Access Compliance Report Public Rights-of-Way (Pedestrian Signals)

Main Street: **W_ORANGE_AVE** Cross Street: **GILBERT_ST** Location: **SW**

ADA ID: **SGRK210927112203** Signal Type: **One Push Button-Non APS** Overall Compliance: **No** Severity Scores: **BTN 1: 35** **BTN 2: N/A** **No BTN: N/A**

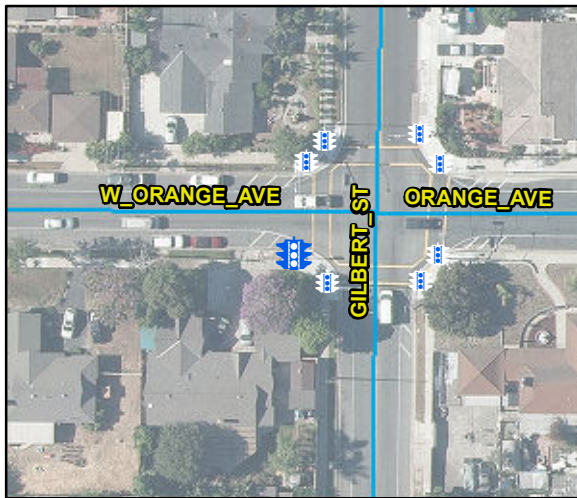
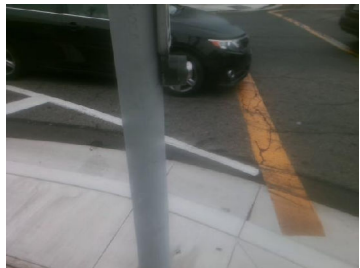
OC Std/PROW: **R404.2, MUTCD 4e.08**

Possible Solutions: Replace Signal Push Button With APS Button. Remove and Replace Clear Space.
